CITY OF LA VISTA
MAYOR AND CITY COUNCIL REPORT
APRIL 18, 2023 AGENDA

Subject:	Type:	Submitted By:
PUD SITE PLAN AMENDMENT LOTS 1-3 & OUTLOT A SOUTHPORT WEST REPLAT 8	◆ RESOLUTION ORDINANCE RECEIVE/FILE	CHRISTOPHER SOLBERG DEPUTY COMMUNITY DEVELOPMENT DIRECTOR

**CITY OF LA VISTA
PLANNING DIVISION
LA VISTA RECOMMENDATION REPORT**

RE: Planned Unit Development Amendment – Initial Review Letter
Lots 1, 2, 3, and Outlot A Southport West Replat 8

VICINITY MAP

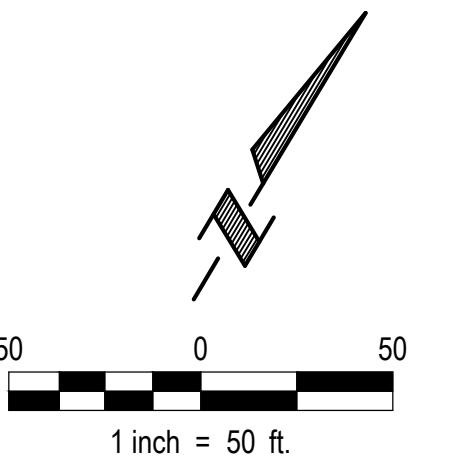
1. As per Section 5.15.05.06 a vicinity map needs to be included in the PUD Site Plan that meets the requirements of the aforementioned section of the Zoning Ordinance. Although a vicinity map has been provided on the latest submittal, the location it depicts is wrong.

1. As per Section 5.15.5.06 a vicinity maps needs to be included in the PUD Site Plan that meets the requirements of the aforementioned section of the Zoning Ordinance. Although a vicinity map has been provided on the latest submittal, the location it depicts is wrong.

Response: The Vicinity Map has been revised as noted.

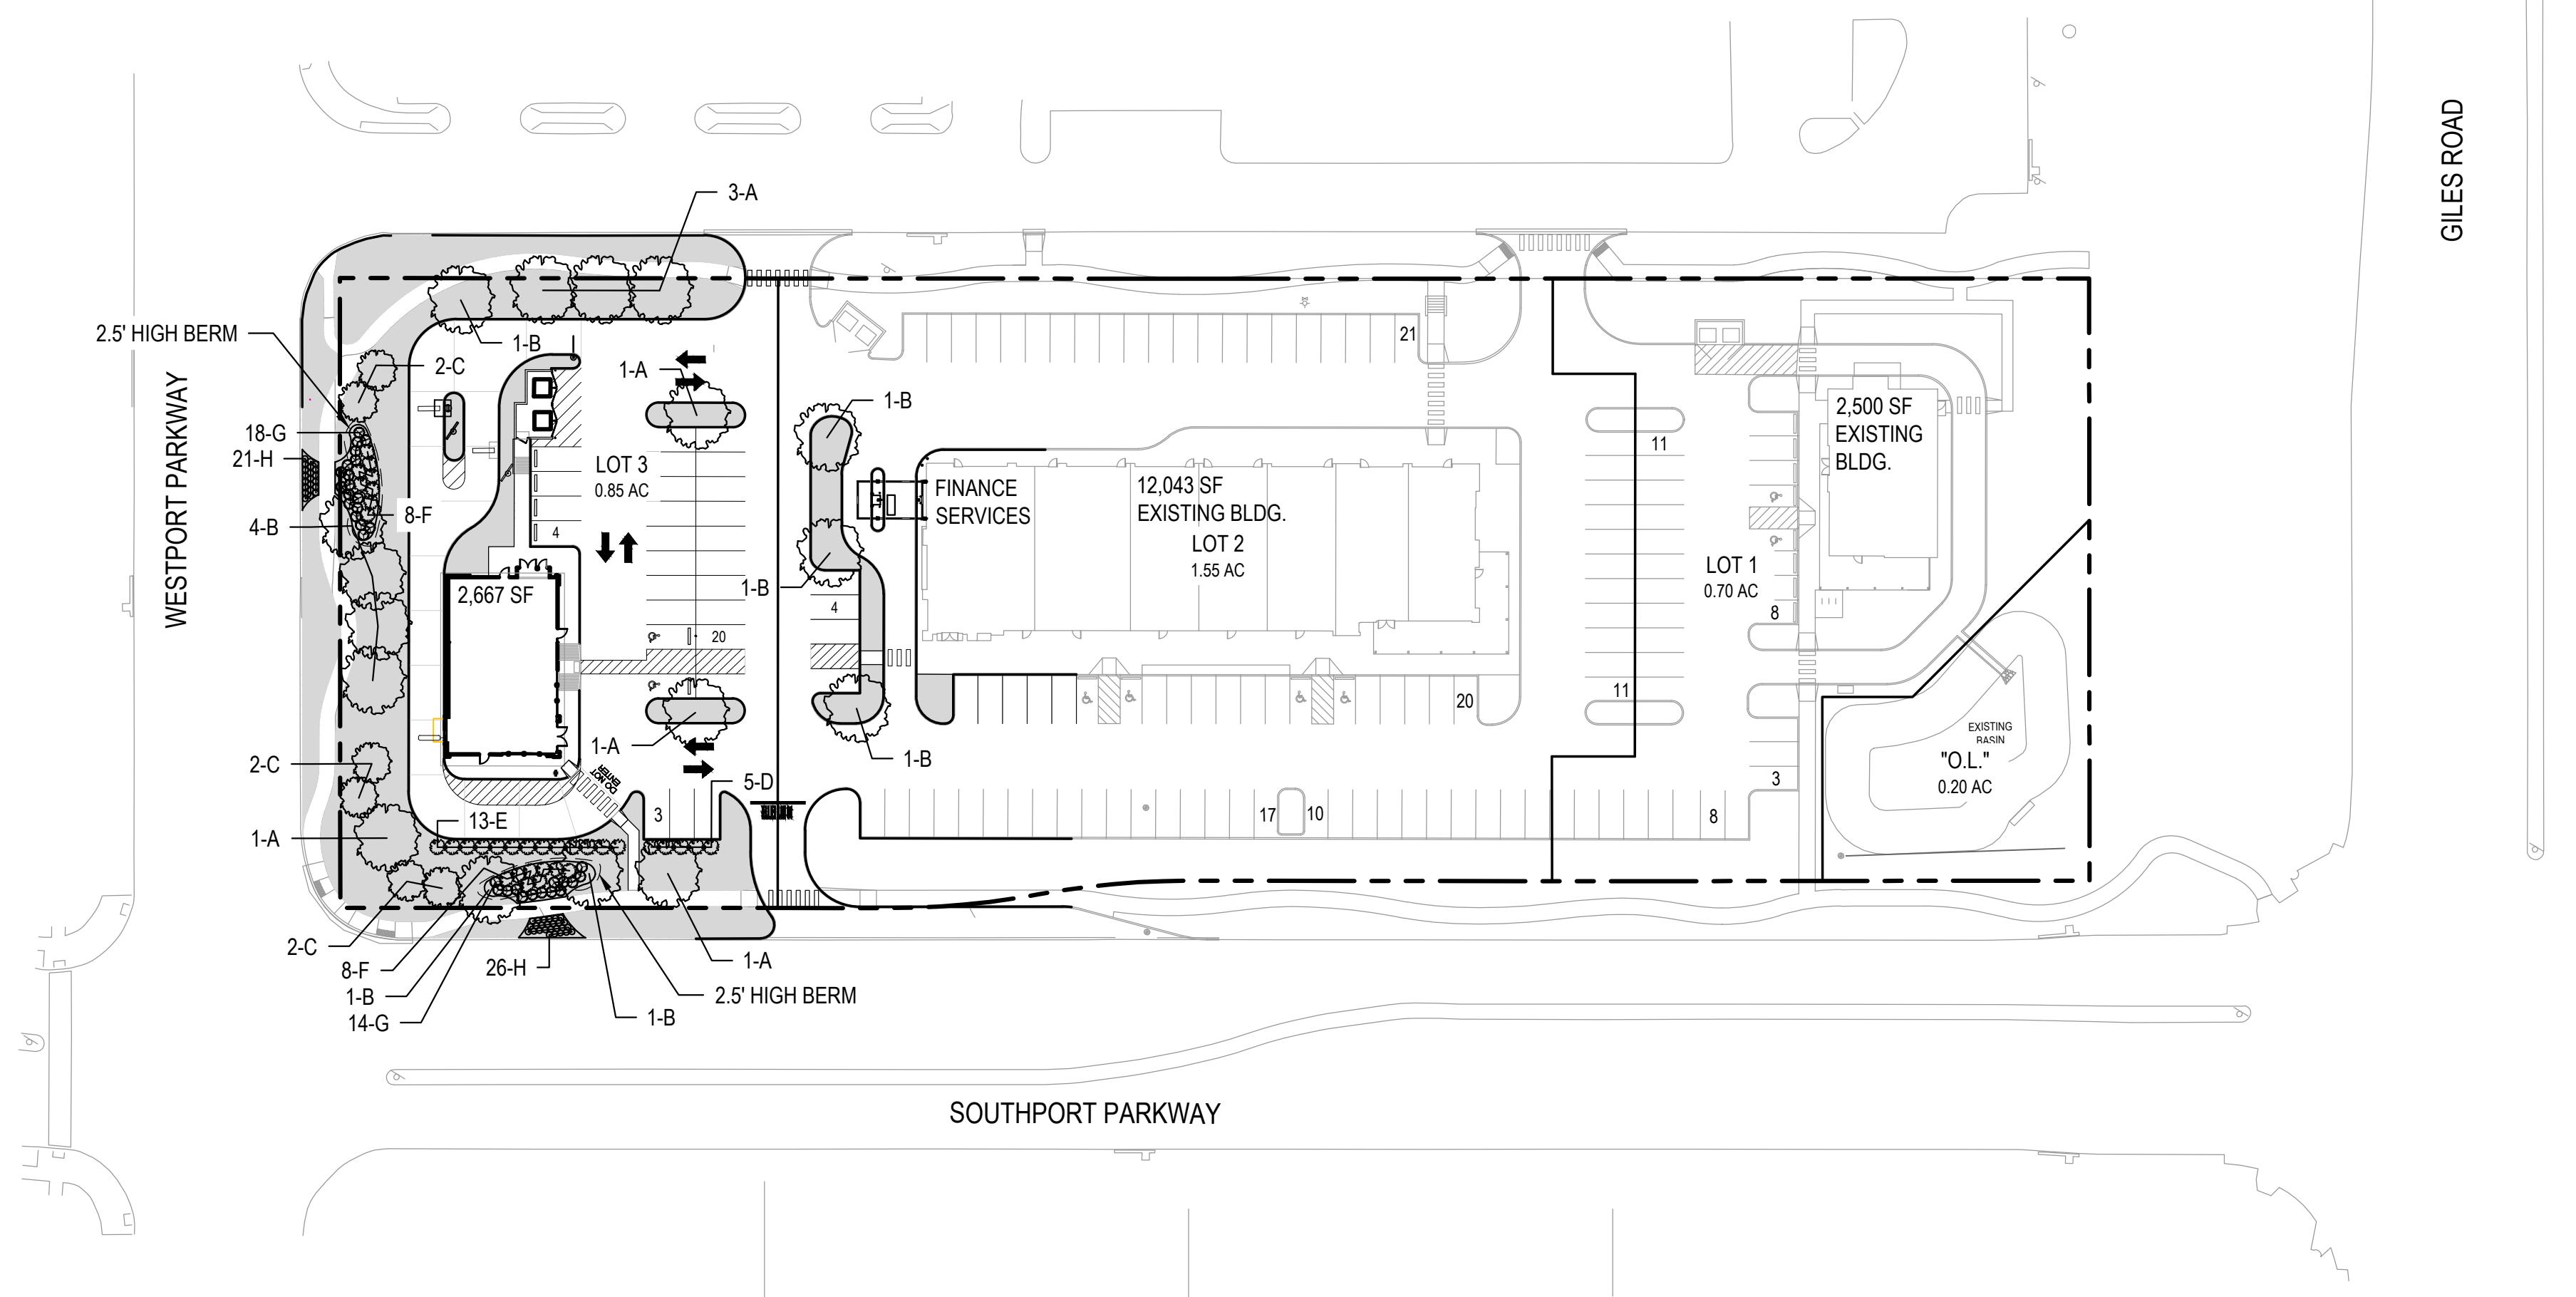
1. The original PUD plan set calls for berthing along Southport Parkway and Westport Parkway. Please return the required berthing into the Landscape & Grading Plans to a height of 2 1/2 feet above the curb line.

1. Landscaping
 - i. Plants with type marks B, C & E on the planting schedule are not included in the approved plant list in appendix C.

Response: This revision has been completed.
 - ii. Deciduous shade trees are required to have a 3" caliper. Trees proposed in Planting Schedule is shown as a 2" caliper, revise as required.

- iii. Deciduous shrubs are required to be 5 gallons. Shrubs proposed in Plant Schedule is shown as a 3 gallon, revise as required.
Response: This revision has been completed.
- iv. 6.I.C requires a' bermed, landscaped, sodded and irrigated green space along secondary (Southport Parkway & Westport Parkway) street frontages. The grading plan does not indicate any bermming along these frontages.
Response: This revision has been completed.

Response: The berthing & landscaping has been added to the Landscape Plan & Grading Plan.

Response: This revision has been completed.

Figure 9. Site circulation conceptual improvements

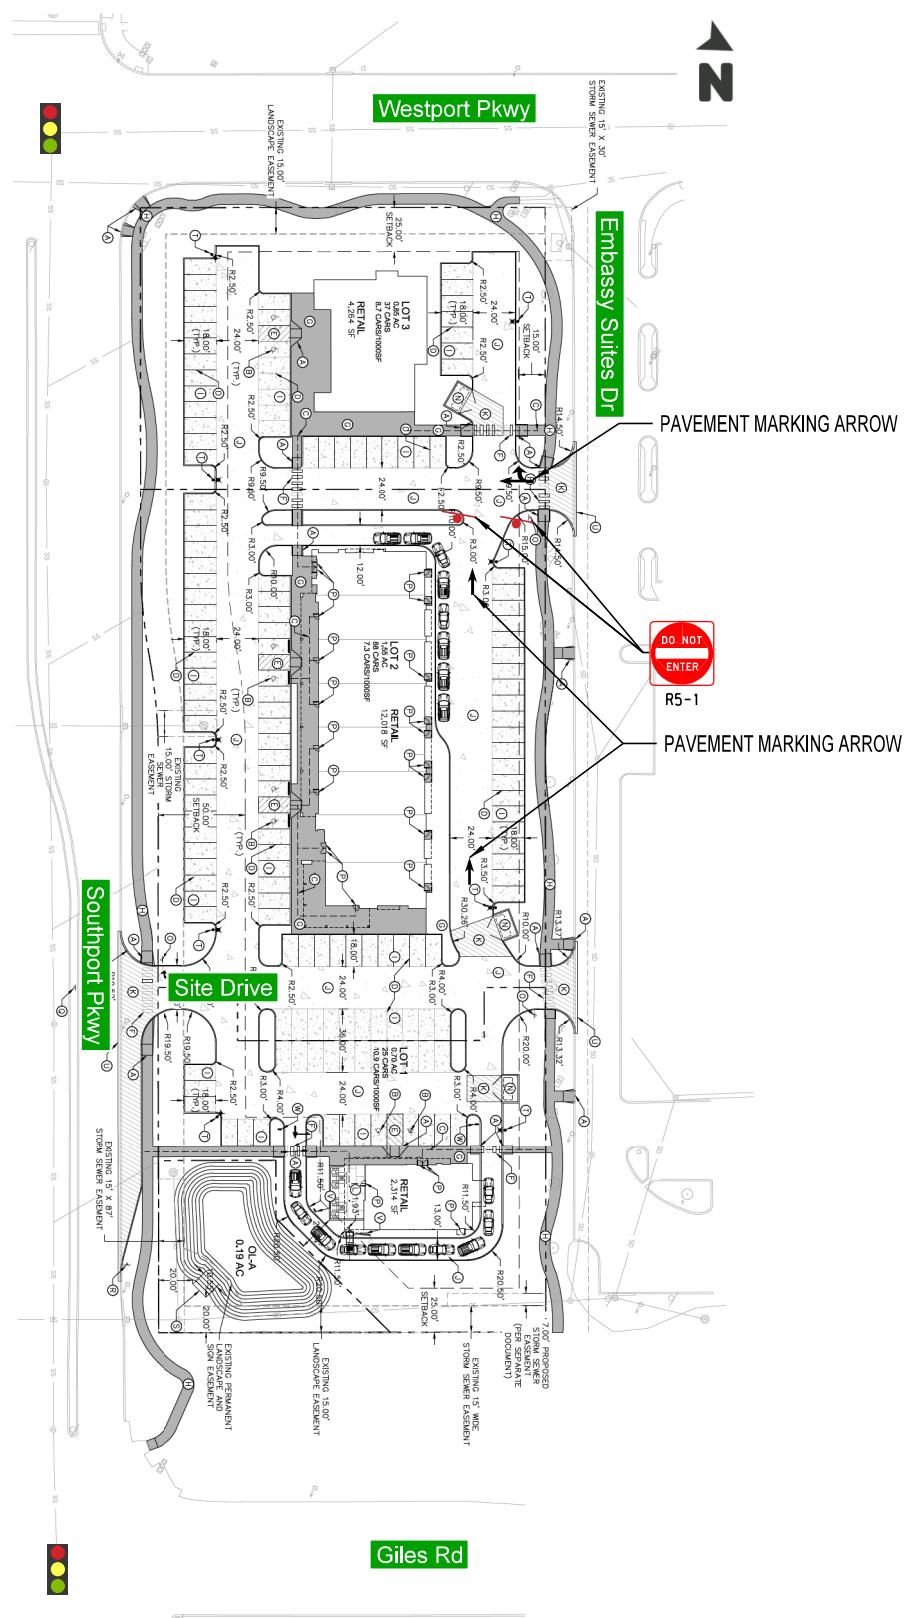
The available stacking for the fast-food restaurant (center building) shown in the site plan is eight vehicles in a dedicated storage lane. The 24-foot drive aisle on the north side of the building should be one-way westbound to avoid conflicts with circulation and drive-through access. Do Not Enter (MUTCD sign R5-1) signs and pavement marking arrow symbols should be installed to guide site traffic. **Figure 9** shows a concept of these signage and pavement marking improvements.

Based on the current site plan, the drive aisle on the north side of the central building should be one-way westbound to avoid conflicts with circulation and drive-through access. Do Not Enter (MUTCD sign R5-1) signs and arrow pavement markings should be installed to guide site traffic.
